**REFER TO BULLETIN SER 74 GEN-16**

**PROBLEM**

For the 1974 Z1A, H2B, H1E, and S3 models, new style front fork damper cylinders were developed to improve performance and eliminate the clunking noise.

**S SERIES**

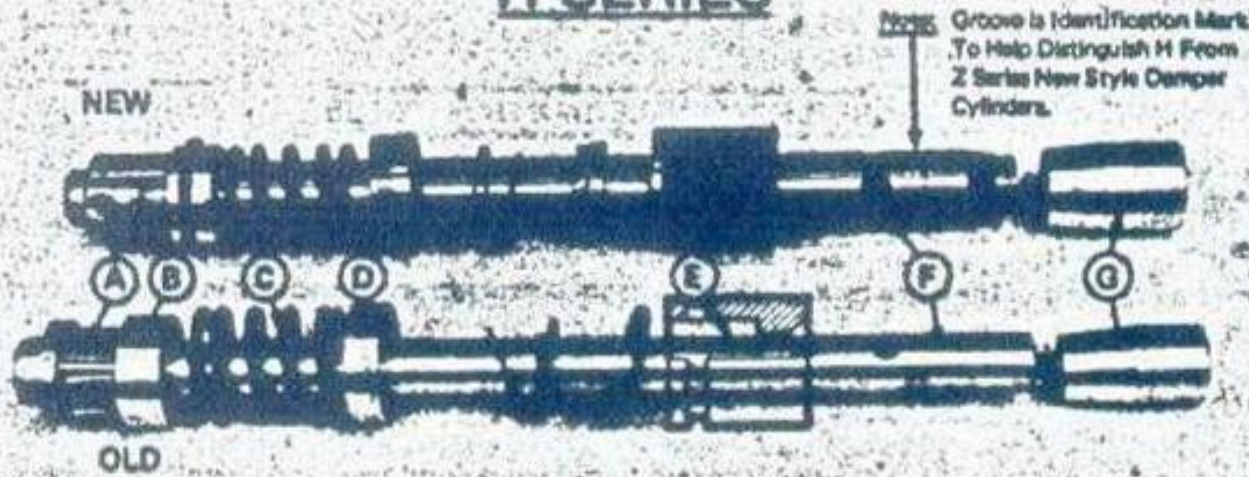
A	B	C	D	E	F	G
	DAMPER CAP	PISTON	REBOUND CUSHION SPRING	VALVE	FORK PISTON	CYLINDER	TAPERED CYLINDER BASE
NEW	CLOSED TOP	NO RING	30mm LONG	STEEL	P/N 44018-009	STEEL 17mm DIA	ALUMINUM 22mm DIA
OLD	OPEN TOP	NO RING	33mm LONG	ALUMINUM	P/N 44018-001	ALUMINUM 13mm DIA	ALUMINUM 18mm DIA

# Z SERIES

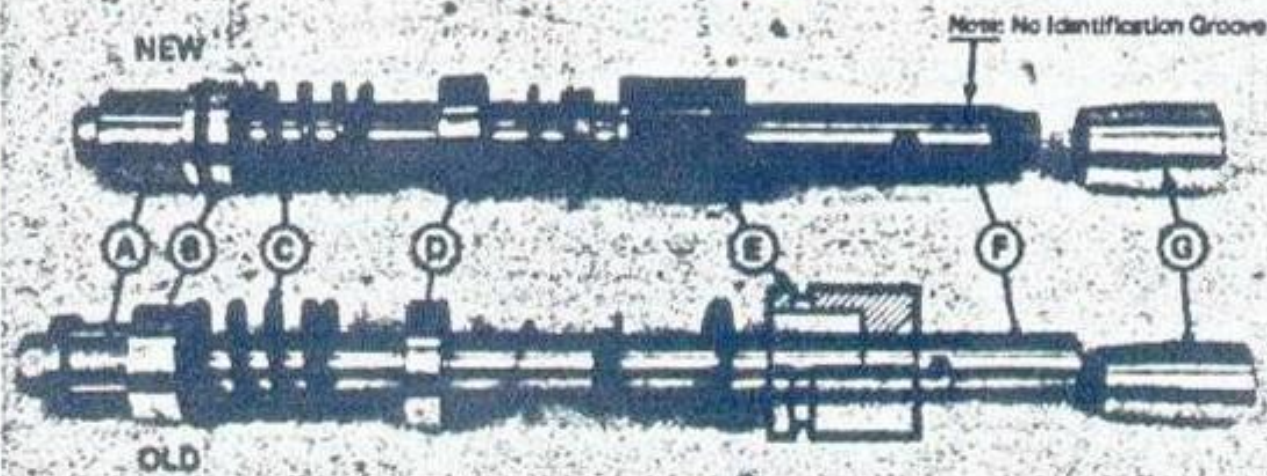
A	B	C	D	E	F	G
	DAMPER CAP	PISTON	REBOUND CUSHION SPRING	VALVE	FORK PISTON	CYLINDER	TAPERED CYLINDER BASE
NEW	CLOSED TOP	PHENOLIC PISTON RING	30mm LONG	STEEL	P/N 4401B-009	STEEL 17mm DIA.	ALUMINUM 22mm DIA
OLD	OPEN TOP	NO RING	33mm LONG	ALUMINUM	P/N 4401B-003	ALUMINUM 13mm DIA.	ALUMINUM 18mm DIA
